Appl. No. 10/650,504
Amdt. Dated December 20, 2005
Reply to Office Action of September 26, 2005

Attorney Docket No. 81872.0052
Customer No.: 26021

REMARKS/ARGUMENTS

FIG. 9a

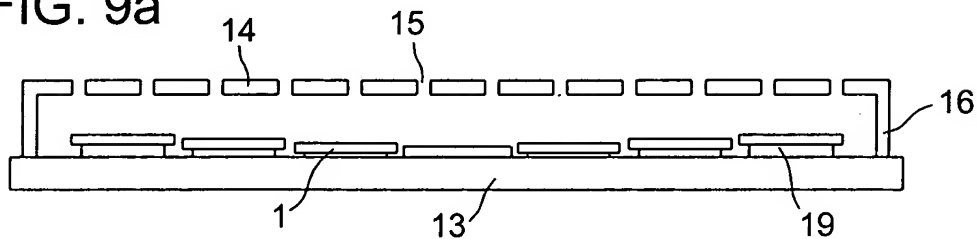
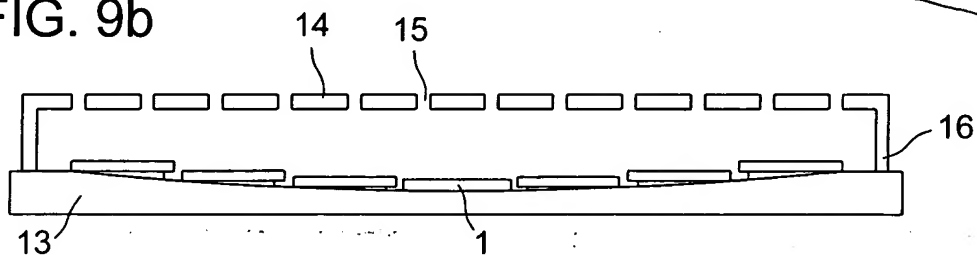
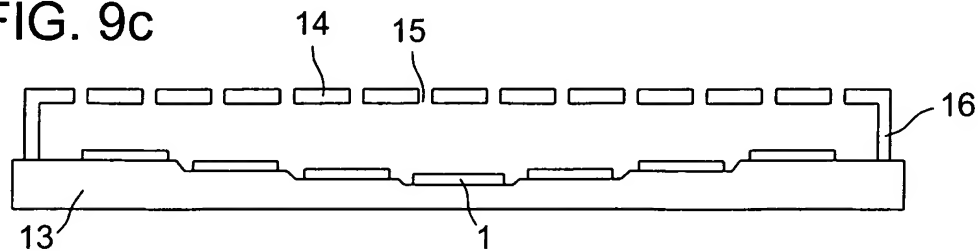
The drawings stand objected to under 37 CFR 1.83(a) as failing to show every feature of the invention specified in the claims. The Office states that the concave substrate-placing surface of the tray must be shown.

In response, Applicant has amended Fig. 9 and replaced it with Fig. 9a, Fig. 9b, and Fig. 9c, which show the concave substrate placing surface of the tray. No new matter has been added. A description of the concave substrate-placing surface of the tray 13 can be found in the Applicant's specification at p. 20 lines 13-21. It would be ordinary and clear to one skilled in the art that Fig. 9a, Fig. 9b, and Fig. 9c meet the technical specification found therein.

The attached sheet of drawings includes changes to Figures 9a, 9b, and 9c.
